Site Accessibility Evaluation

Americans with Disabilities Act Title II (Public Services: State and Local Government)

Centennial Hall

Accessibility Evaluation

Finding: 1

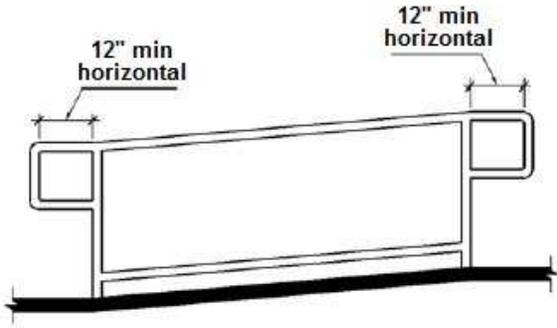
The handrail does not extend horizontally.

Handrail does not extend full length of ramp

Modify existing handrails to extend the full length of the ramp.

Finding: 2

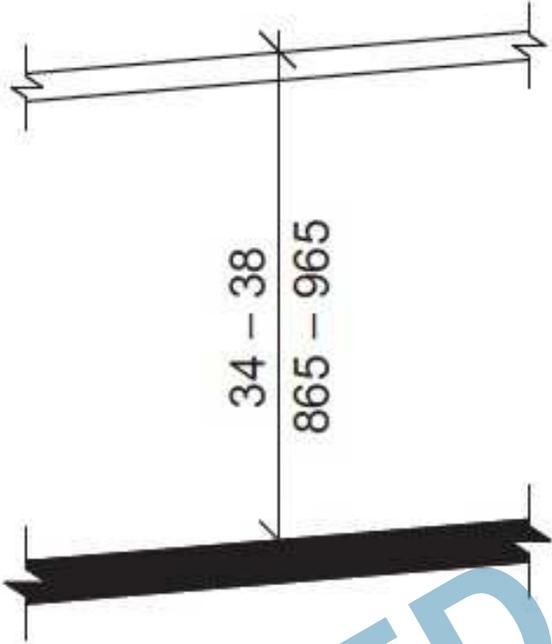
The handrails are mounted too low.

Handrail height
between 32 and 33
inches above finished
floor

Modify existing handrails and ensure handrails are installed between 34 inches and 38 inches above finished floor.

Finding: 3

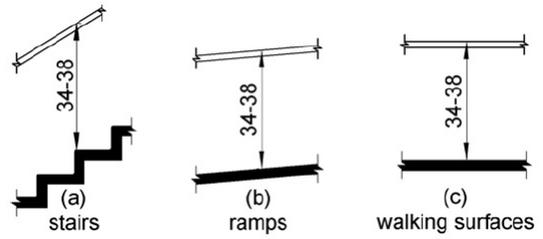
The handrails as well as the handrail extensions are not at the correct height.

Handrails below 34 inches minimum height required

Re-place existing handrails with handrails no lower than 34 inches from the top of the gripping surface and ensure extensions are also included at the top and bottom landings.

Finding: 4

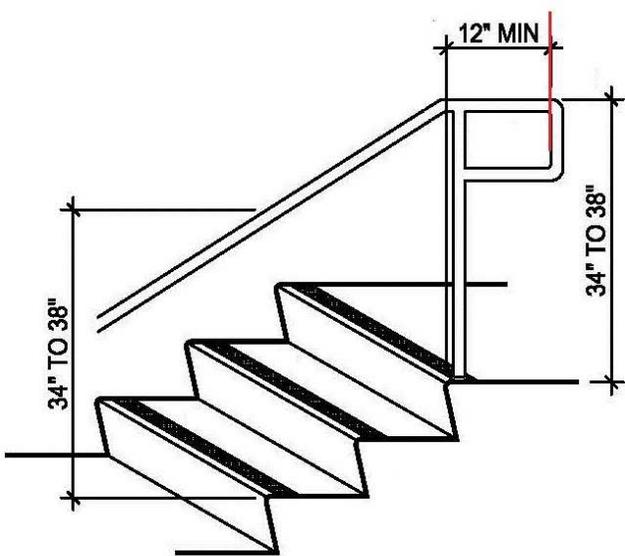
The handrail projects less than 12 inches beyond the landing at the top of the stairs parallel to the floor or ground.

31.75 inches above finished floor

Full length of extension must be **HORIZONTAL**

Re-construct or modify existing handrails and ensure handrails are installed between 34 inches and 38 inches above finished floor and extend horizontally above the landing for 12 inches minimum.

Finding: 6

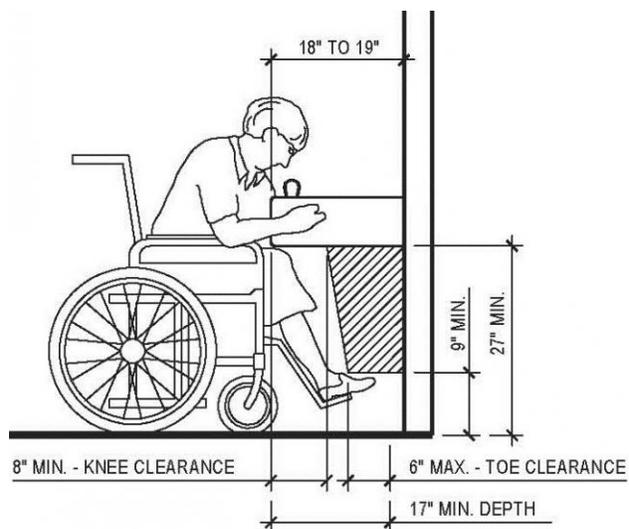
There is not enough knee clearance under the drinking fountain.

Bottom edge of
drinking fountain at
26.5 inches

Adjust drinking fountain height to provide 27 inches of clearance.

Finding: 7

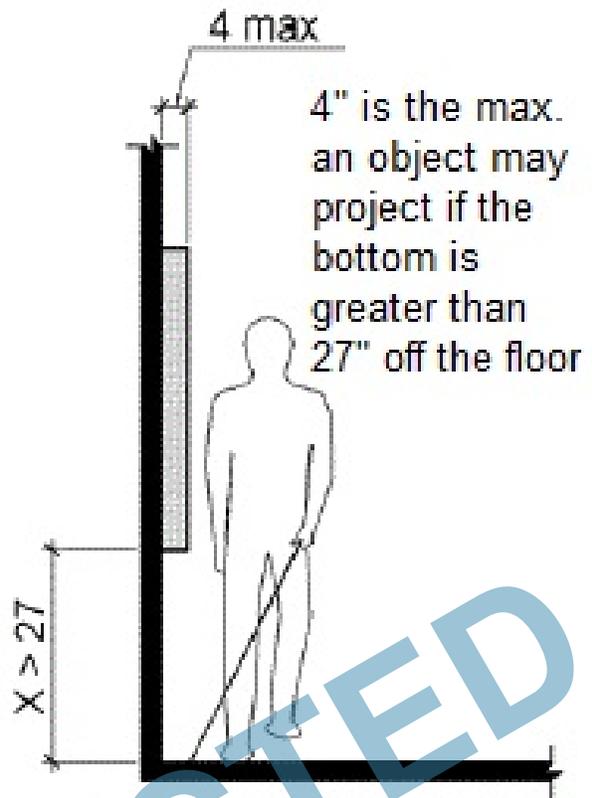
The fire alarm housing projects more than 4 inches into the circulation path.

Protrudes 6 inches
from wall

If possible, replace fire alarm housing with low profile housing or recess housing into wall to meet the 4 inch maximum protrusion.

Finding: 8

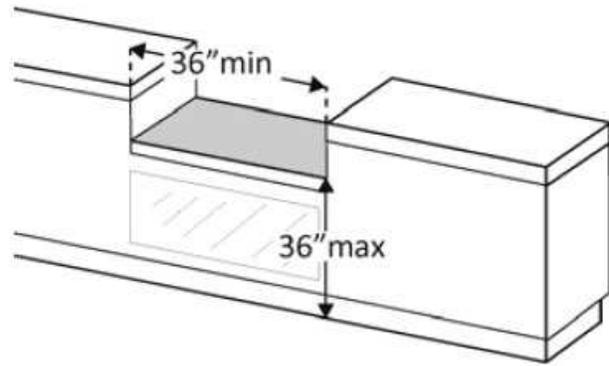
The transaction counter is too high.

42 inches above
finished floor

Install compliant service counter or addition to existing service counter that includes a section of counter surface that is 36 inches long minimum and 36 inches high maximum.

Finding: 10

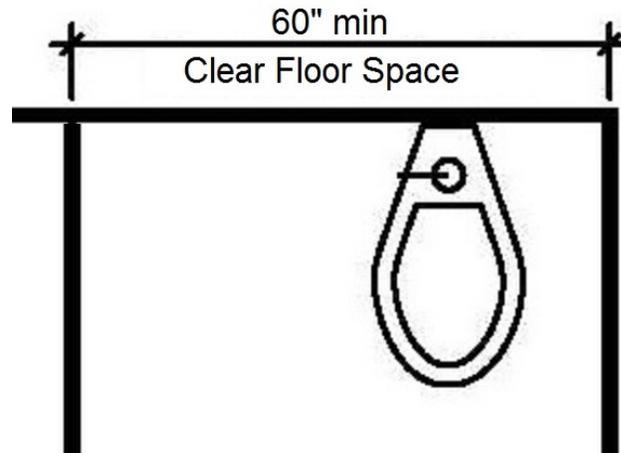
The toilet compartment is not wide enough.

40 inches wide

Re-design and remodel restroom to meet compliance to the extent feasible.

Finding: 11

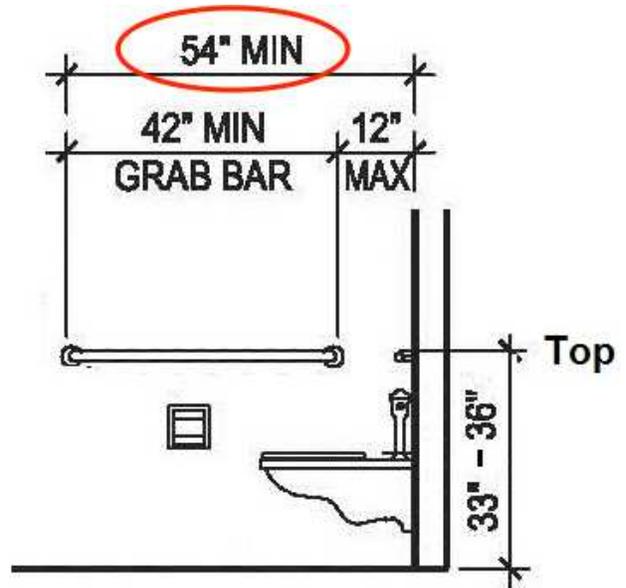
The side grab bar does not extend far enough from the rear wall.

10 inches from rear wall

Upon remodel install new side grab bar to meet compliance.

Finding: 12

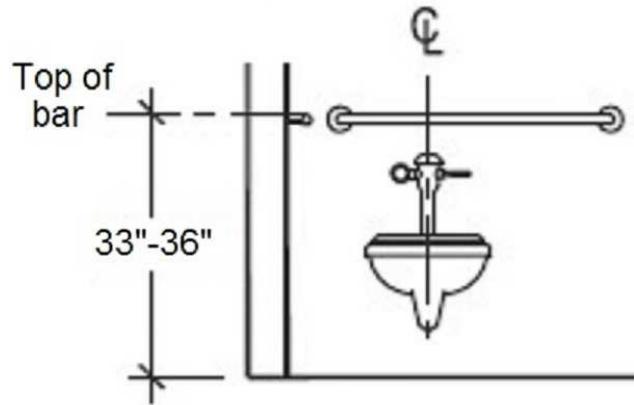
The rear grab bar is too high.

37 inches above
finished floor

Lower grab bar between 1 and 3 inches to meet compliance.

Finding: 13

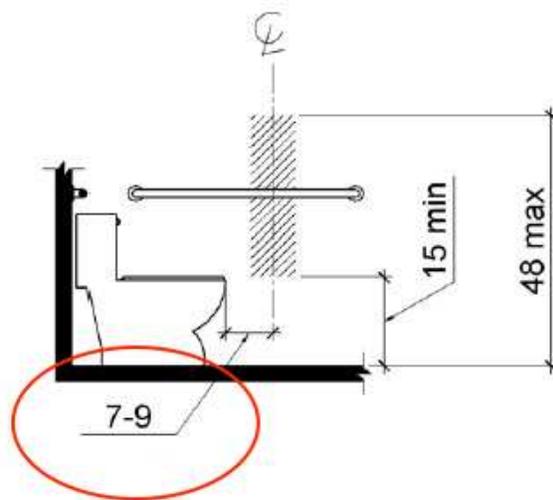
The toilet paper is not installed within the compliant range in front of the toilet.

2 inches in front of toilet

Re-design and remodel restroom to meet compliance to the extent feasible.

Finding: 14

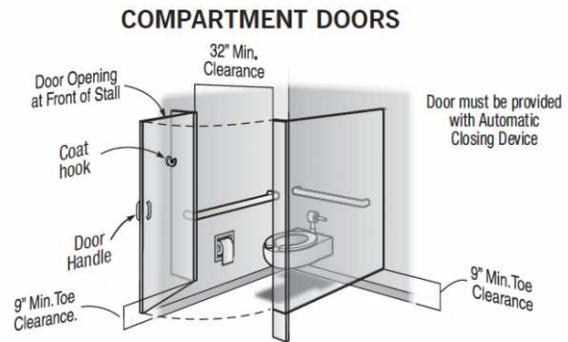
The compartment door is not self closing.

Door not-self closing

Re-design and remodel restroom to meet compliance to the extent feasible.

Finding: 15

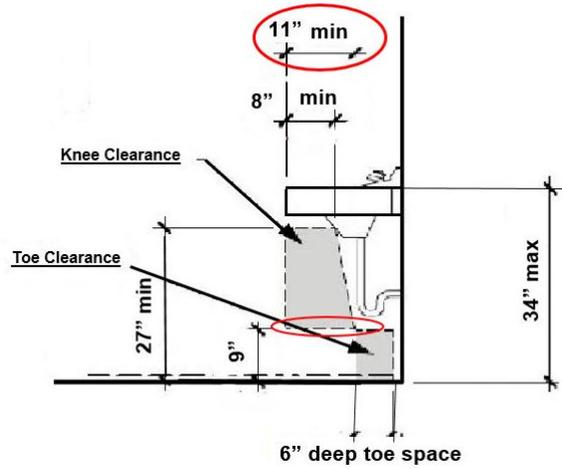
Compliant knee space has not been provided under the lavatory.

No knee clearance provided

Replace lavatory with compliant unit that meets ADA standards.

Finding: 16

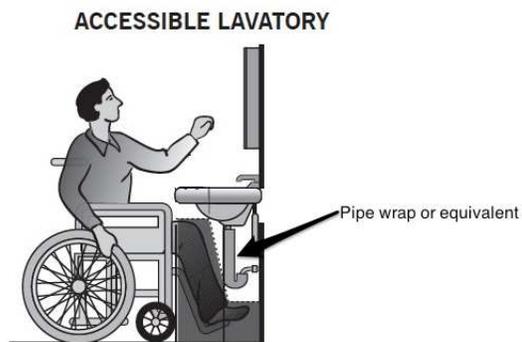
The water and drain pipes under the lavatory are not adequately insulated.

No insulation installed

Install pipe insulation prior or during re-model.

Finding: 17

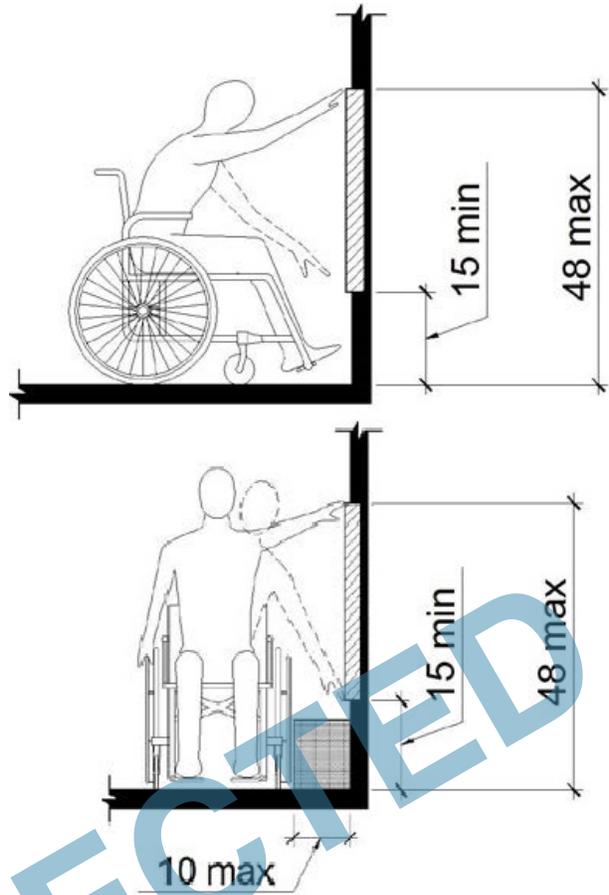
The baby changing table operating mechanism is outside reach range.

Operable part is at 60 inches above finished floor

Replace with horizontal baby changing table and install with operable handle no higher than 48 inches above finished floor.

Finding: 18

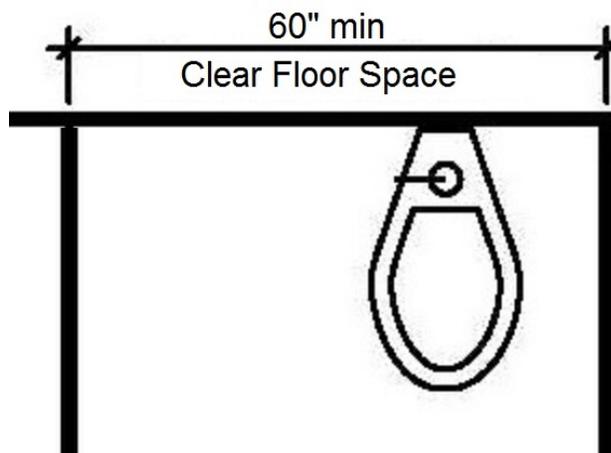
The toilet compartment is not wide enough.

41 inches wide

Re-design and remodel restroom to meet compliance to the extent feasible.

Finding: 20

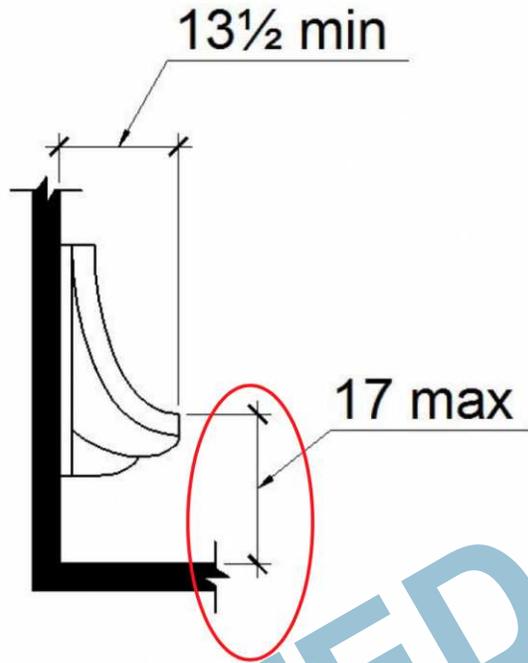
The rim of the urinal is too high.

18.5 inches above finished floor

Lower urinal 2 inches or replace with compliant urinal.

Finding: 21

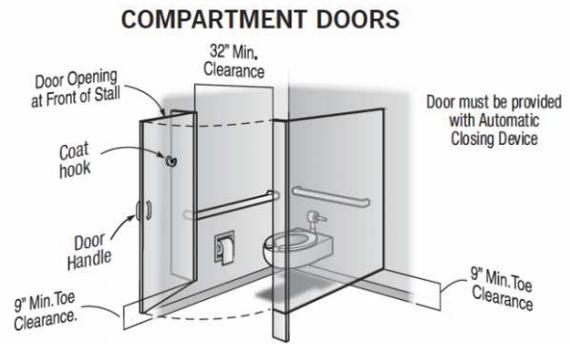
The compartment door is not self closing.

Door not-self closing

Re-design and remodel restroom to meet compliance to the extent feasible.

Finding: 22

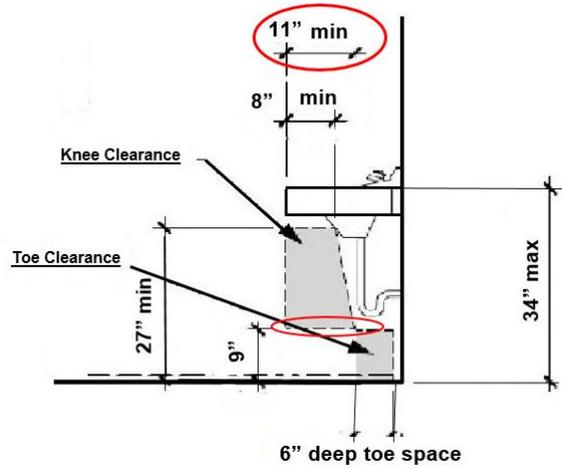
Compliant knee space has not been provided under the lavatory.

No knee clearance provided

Replace lavatory with compliant unit that meets ADA standards.

Finding: 23

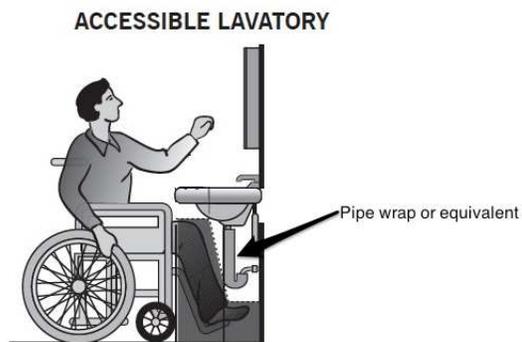
The water and drain pipes under the lavatory are not adequately insulated.

No insulation installed

Install pipe insulation prior or during re-model.

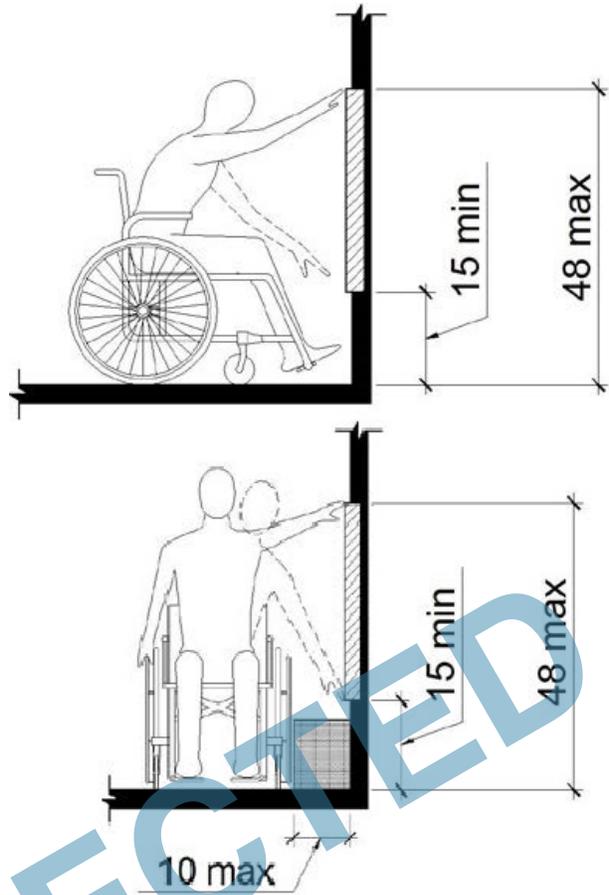
Replace with horizontal baby changing table and install with operable no higher than 48 inches above finished floor.

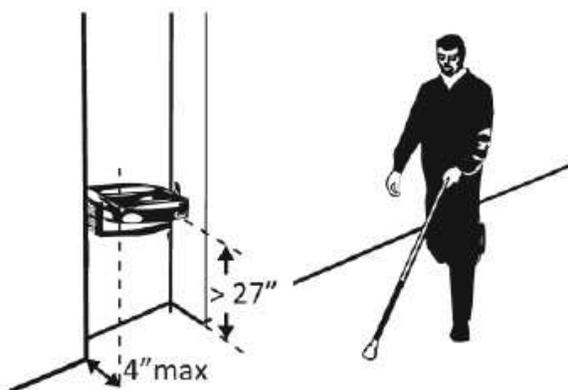
Adjust drinking fountain height to provide exactly 27 inches of clearance or install wing walls, planter or permanent fixture next to drinking fountain in order to make it cane detectable.

Trash cans were added on both sides of the drinking fountain for white cane detection.
